## Bulletin 001: Flextone HD

## Bulletin 02: Flexitone II

## Bulletin 03: MM4 and DL4

## Bottom side view of PCBA

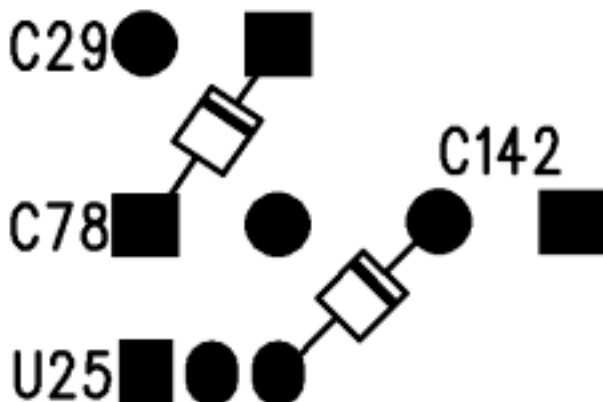
**Repair Procedure** Add one 1N4002 (06-04-4002) diode at each of the outputs of the +/- 15V regulators. (See diagram below)

1. Place unit upside down with the back panel facing you.
2. Remove bottom cover of chassis.
3. Clip leads on two 1N4002 diodes (06-04-4002), keeping the leads as short as possible.
4. Solder diode from pin#1 of C78 to pin#1 of C29. Cathode side of diode connects to C29. (See diagram below)
5. Solder diode from pin#3 of U25 to pin#2 of C142. Cathode side of diode connects to C142. (See diagram below) (U25's pins are located approximately 3<sup>1</sup>/<sub>2</sub>" from the right side of the PCB and 2<sup>1</sup>/<sub>4</sub>" from the back side of the PCB (the side with the output jacks.)
6. Carefully check that both diodes are oriented correctly.

**Fig 1.**

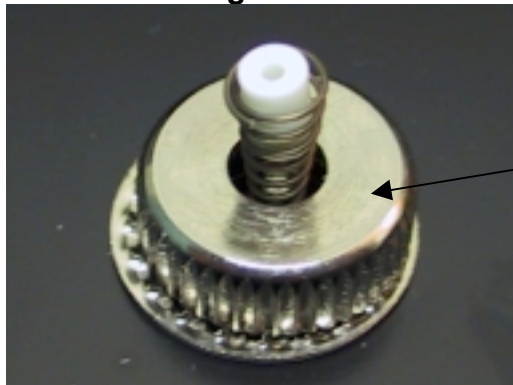
**Repair Procedure :** Remove bottom plate of floorboard by removing the 6 screws on the bottom and the 2 screws on each side. Remove the bottom plate. Remove the 6 screws that are holding the switch board (the largest of the 3 circuit boards) in place and move the board out of the way so as to expose the switch actuators. Check that all the actuator springs are properly situated. Insert spacer (part # 30-15-0009; see Fig. 1) into the center of each switch actuator. Replace PCB and bottom cover.

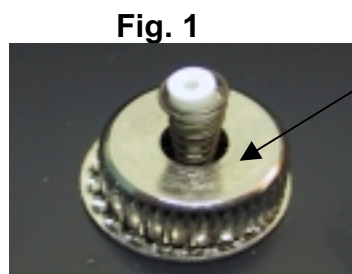
**Repair Procedure** : Using 2 small flathead jeweler's screwdrivers or dental tools placed underneath the knobs and 180 degrees apart, gently pry off the 6 control knobs. It may be necessary to apply electrical tape to the screw drivers or dental tools to avoid chipping the paint off the perimeter of the knob wells. (A set of pliers can be milled concave to the circumference of the knobs by a machine shop to make the removal of these knobs easier. If interested, contact Line 6's service department for details). Remove nuts from the 1/4" jacks. Remove the 5 screws on the bottom plate. Remove bottom plate. Remove the five screws and the 1/4" hex standoff that secure the circuit board. Remove the circuit board so as to expose the switch actuators. Check that all the actuator springs are properly situated. Insert spacer (Part #30-15-0010) into the center of each actuator spring (see Fig. 1.) Replace circuit board, knobs, nuts and bottom plate.

(Tech Bulletin 016 continued)

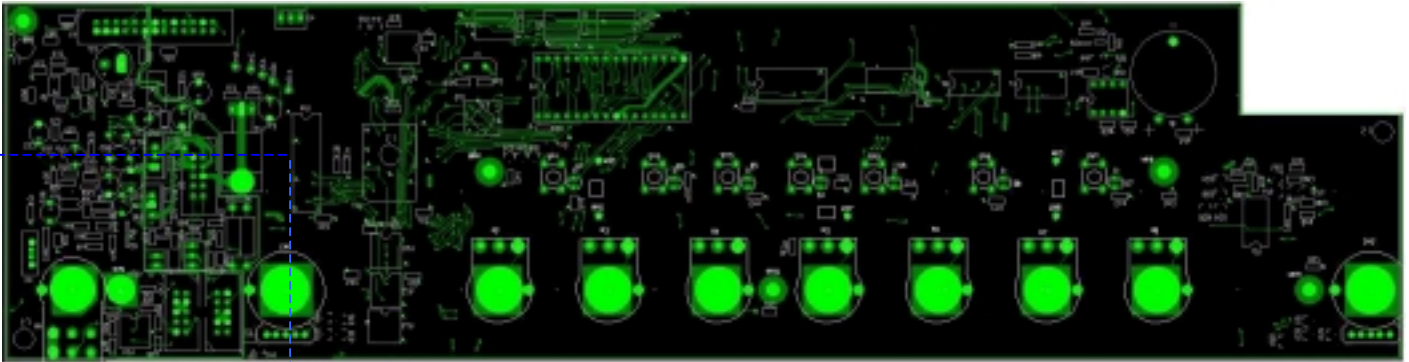
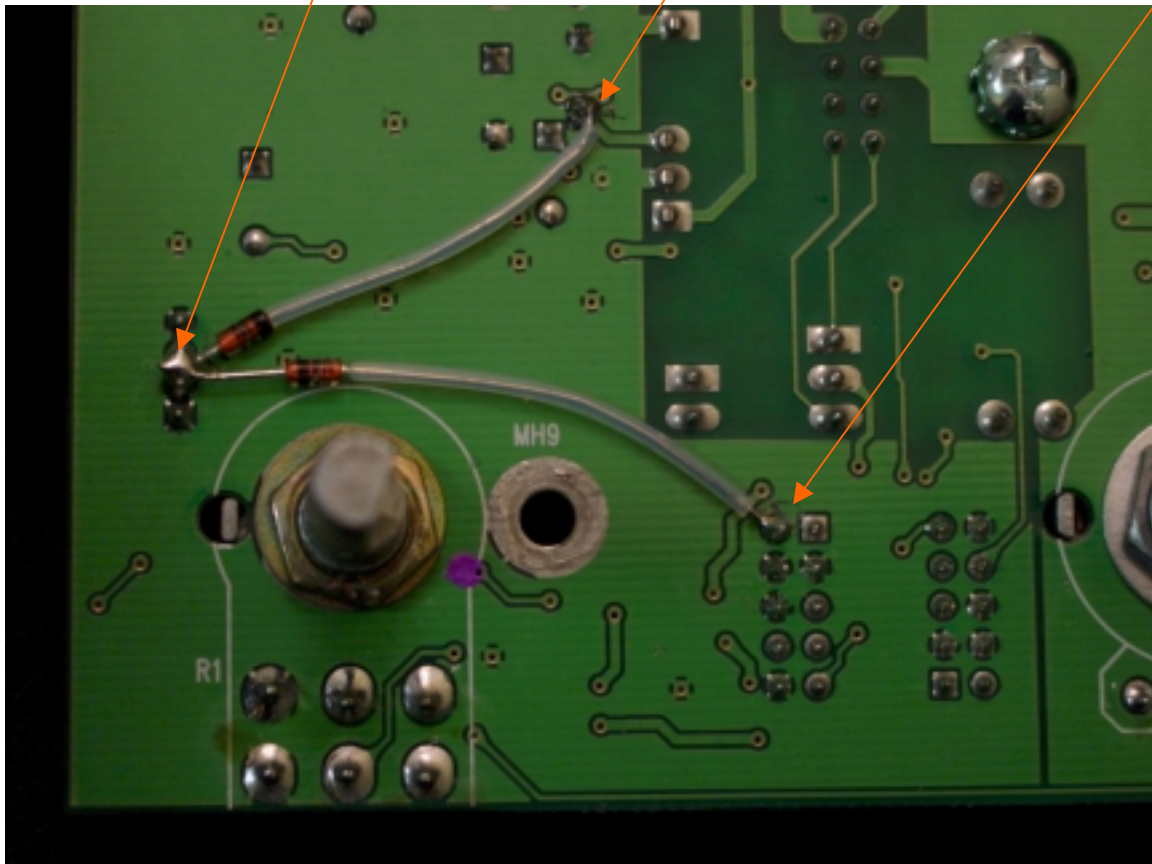
**Repair Procedure :** Disassemble amplifier head (see assembly instructions), remove main board. Install 1N4148 diodes as shown below.

- **INSTALL TWO SMALL-SIGNAL (1N4148) DIODES AS SHOWN BELOW.**
- **INSTALL 22 GAUGE TEFLON TUBING ON LONG LEADS AS SHOWN BELOW.**
- **PROVIDE PLENTY OF CLEARANCE BETWEEN DIODE LEAD AND MOUNTING HOLE MH9 AS SHOWN BELOW.**

KEEP DIODE LEADS VERY SHORT  
TO THIS CONNECTION

CONNECT CATHODE  
OF TOP DIODE  
HERE

CONNECT ANODE OF  
LOWER DIODE HERE

**Fig. 1**

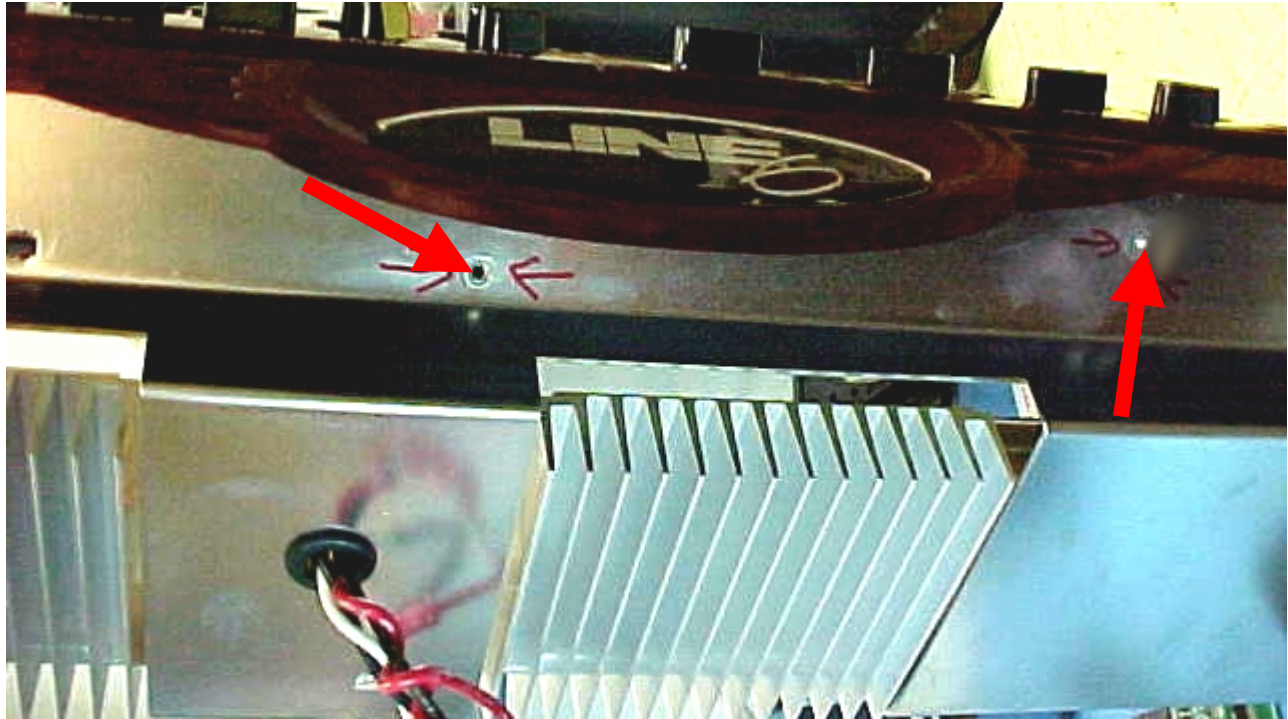
Locate the point on the outside of the chassis where the two hex standoffs are mounted. They are located in the area between the heatsinks and the faceplate overhang. (See Fig. 1)

**Fig. 2**

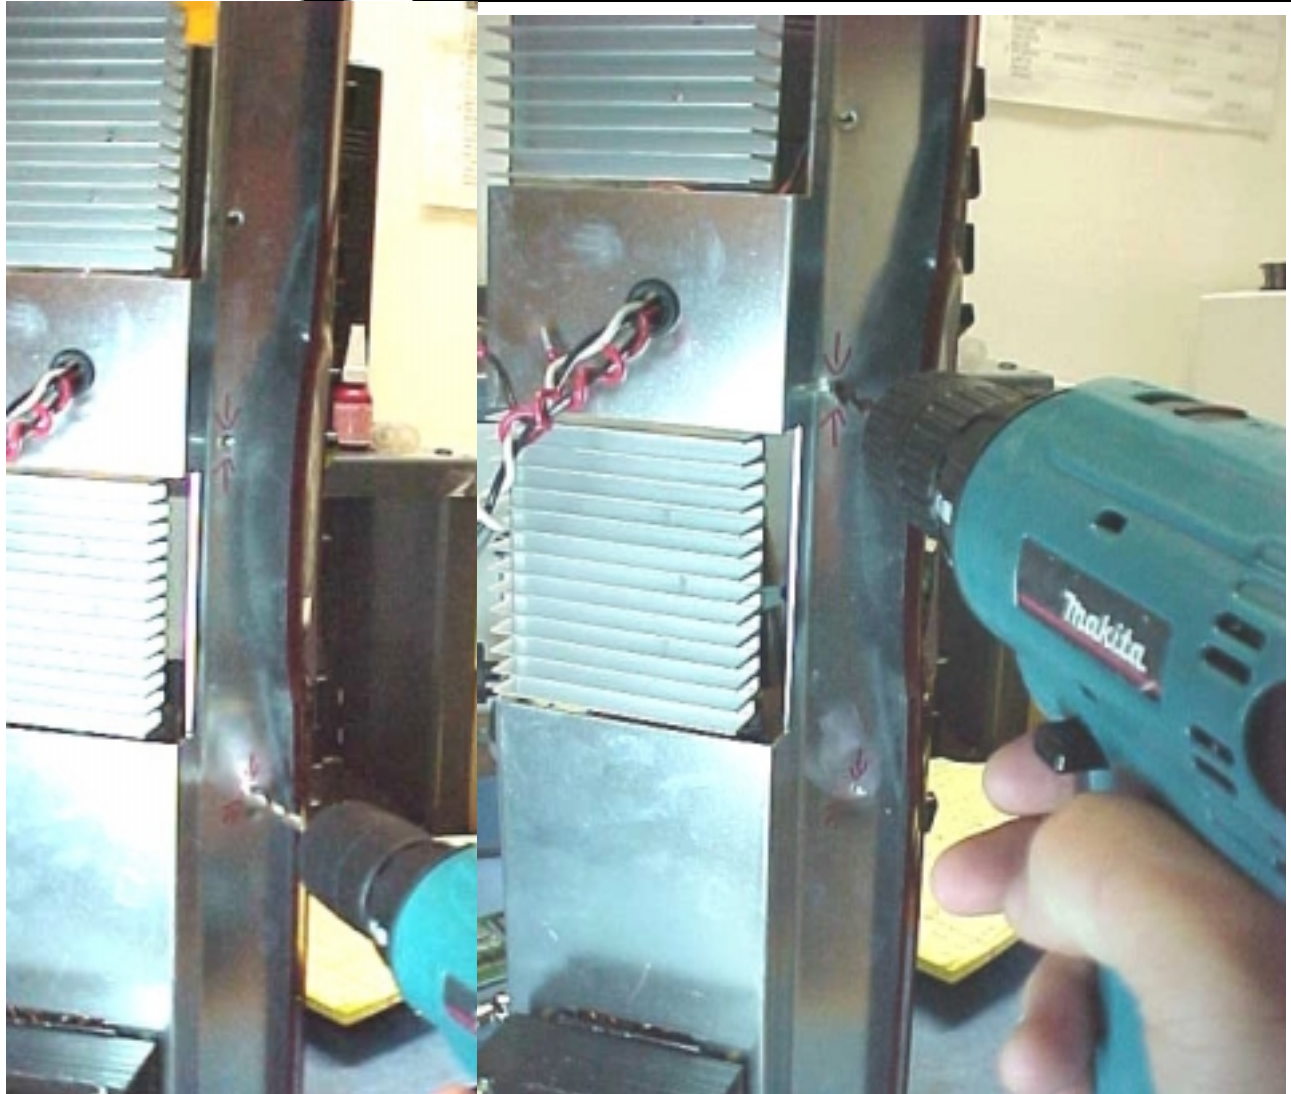
Now drill  $\frac{1}{4}$ " holes in the chassis where the hex standoffs are. Be careful not to drill into the front panel PCBA! (Note: It may be easier if you drill smaller pilot holes into the standoffs first and then gradually work up to the  $\frac{1}{4}$ " drill bit.) In order to avoid metal shavings from getting on the front panel board and causing shorts, it is advisable to drill the chassis while on it's side with the transformer side down (see Fig 2). Additionally, after both holes have been drilled, the chassis and front board should have any metal shavings or other particles blown out by spraying compressed air throughout the chassis and board.

fig. 6

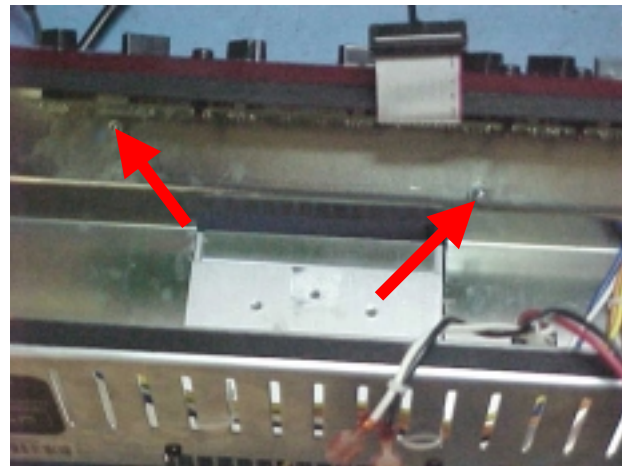
Place washers on the 2 screws (see Fig 3), place screws through holes you've drilled into the chassis from the outside (See Fig. 4). Place a washer on the screw from inside the chassis and then secure one of the threaded spacers onto the screw (see fig. 5 & fig 6). Do not tighten the screw and spacer to the chassis. Drive the screw into the spacer so that the screw just barely extends past the spacer. (If you drive the screw all the way through the spacer, you will not be able to get the main circuit board in place.)

**Fig. 11**

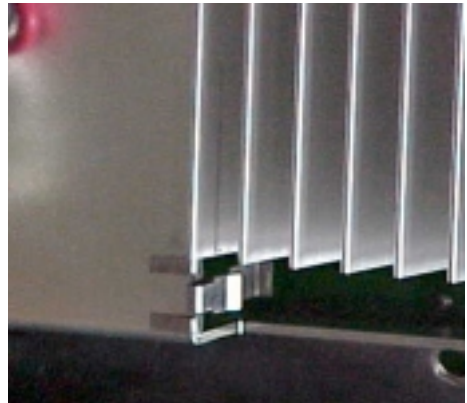
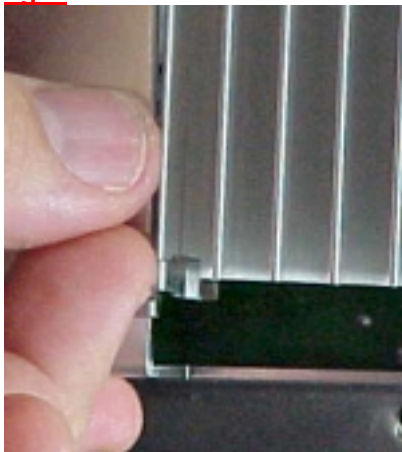
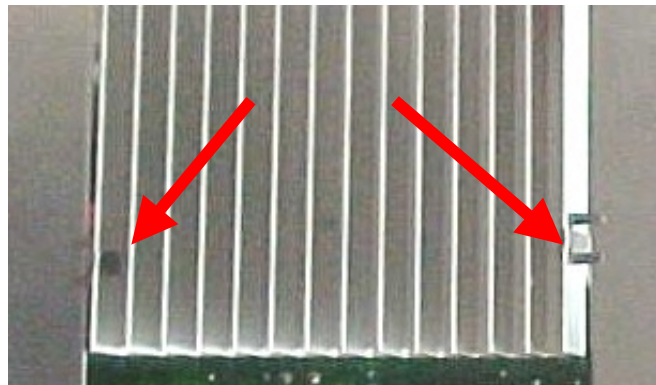
Now before re-installing the main PCBA, loosen, but do not remove, the screws that secure the heatsinks to the chassis so that the heatsinks are loose. (see fig. 7.) Secure one clip (fig. 8) to the chassis on each side of each heatsink (two clips per heatsink)(Fig. 9.)Now slide the clip over the last fin of the heat sink. (fig. 10.) (The hook on the long end should grab the heatsink by the opposite side. ) Slide the clips about an inch up the heatsink (fig. 11) **but do not tighten the heatsinks to the chassis just yet.**

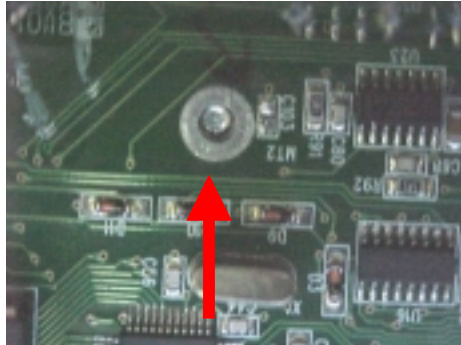
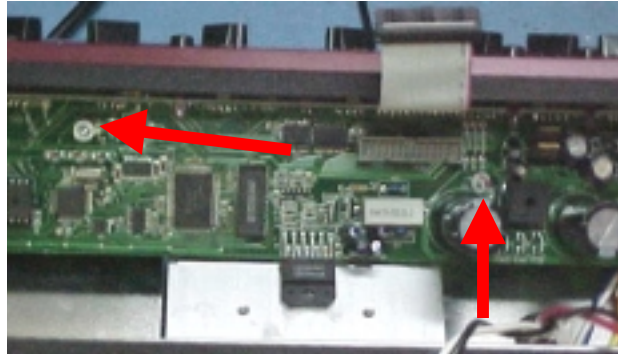
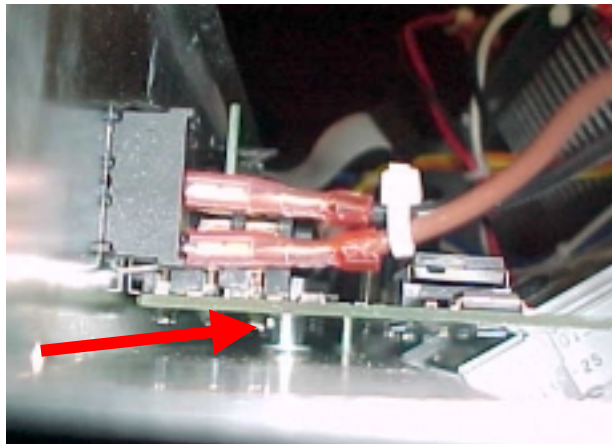
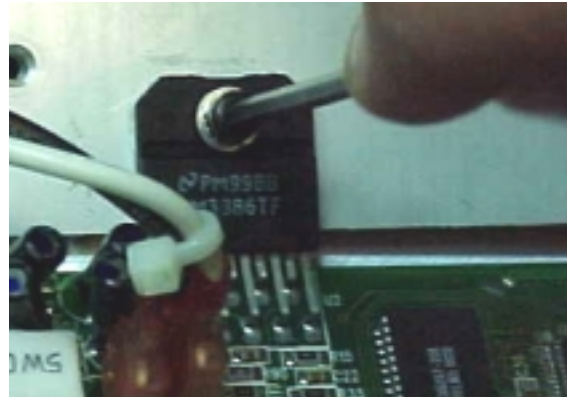
Now reinstall the main PCB by sliding it underneath the front PCBA. Position the board so that the input and headphone jacks fit into their respective mounting holes in the faceplate. Line the PCBA up so that the tips of the screws that are connected to the threaded spacers and chassis show through the holes in the PCBA. (figs. 12, 13 & 14). Drive the screws just a little bit to hold the board in place but do not install the hex nuts to the PCBA screws just yet.

Secure the power IC's to the heatsinks by tightening each IC's hex (or Phillips) screw to 4-5 in/lbs. Apply more heatsink compound if needed. (Do not tighten heatsinks to the chassis just yet.)

**REWORK INSTRUCTIONS - REV.A 2/20/04.**  
**50-02-0236 PCBA POWER SUPPLY w/CONTROL MODERN-HD/VETTA-HD SERIES**

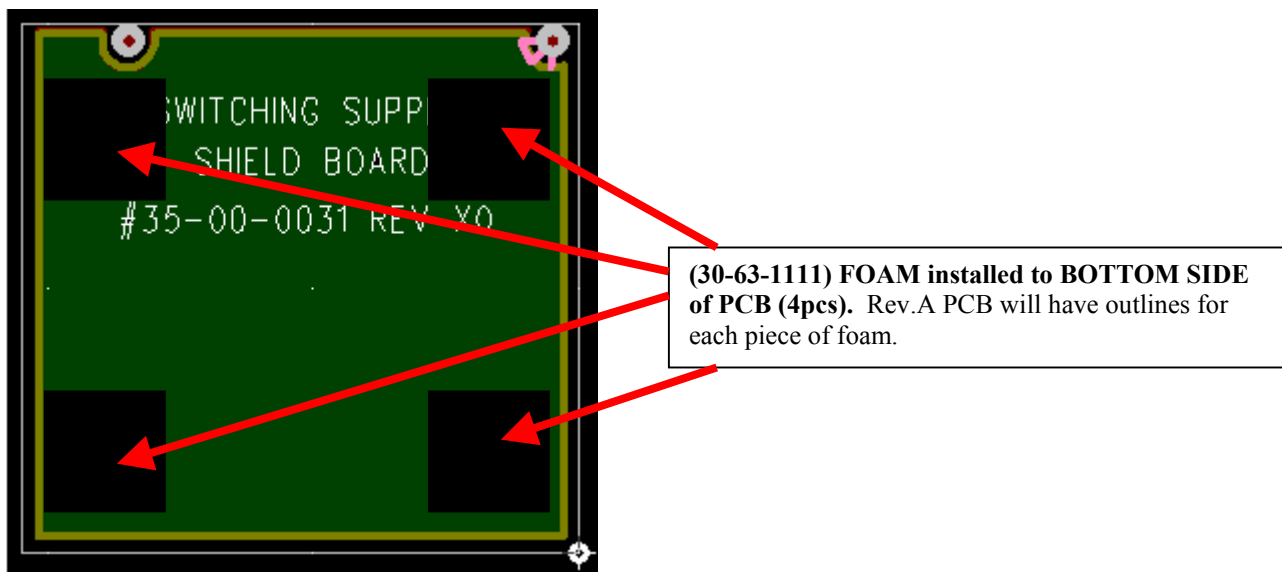
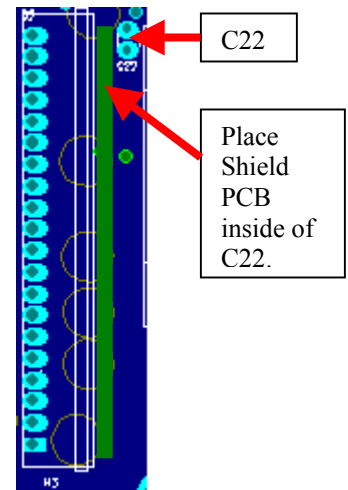
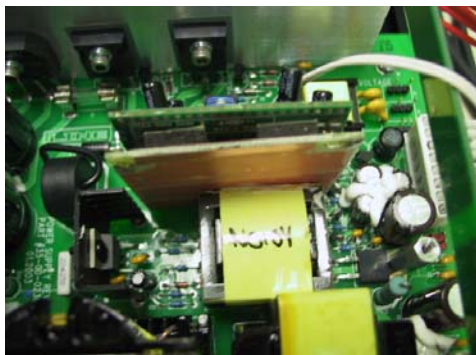
1) Install (4) FOAM 1/2 x 1/2 x 1/8IN w/ADHSV 1-SIDE 3M NO. 4508 (30-63-1111) onto the **BOTTOM** side of the Shield PCB (35-00-0031). It is not necessary to remove the backing on the outside of the Foam.

2) Install the SHIELD PCB onto the Power Supply PCBA with the foam pads facing the Controller PCB (see below). **NOTE** - the bottom edge of the Shield PCB should contact the Power Supply PCB **inside of C22**.

3) Push a piece of stripped jumper wire (22-24AWG) through PIN-1 of the Controller PCBA and through the hole in the Shield PCB that is also aligned with PIN-1. Solder both ends of the wire and trim any excess from the solder contacts. (see below) **NOTE:** the holes on the Controller PCBA may have solder filling them. If so, it will be necessary to heat the solder with a soldering iron while pushing the jumper wire through, or removing the solder from the hole prior to pushing the wire through.

4) Repeat the same process described for PIN-1 above between PIN-17 on the Controller PCBA and the hole that is aligned with it on the Shield PCB. (see below).
